ADDENDUM NO. 1  
DATED MAY 27, 2010

CONTRACT DOCUMENTS AND TECHNICAL SPECIFICATIONS  
FOR THE LAKESIDE DRIVE EXTENSION SANITARY SEWER IMPROVEMENTS

CITY OF SEABROOK PROJECT NO. 2010-04

**SANITARY OR STORM SEWER  
CRUSHED STONE FOUNDATION  
FOR WET STABLE TRENCH**

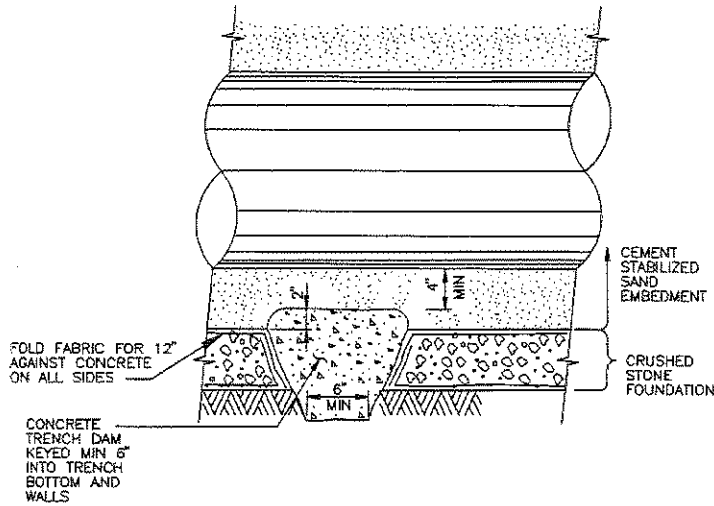
- 1) An 8 ½" x 11" detail for the wet stable trench construction is attached for reference when bidding and construction using wet trench construction.
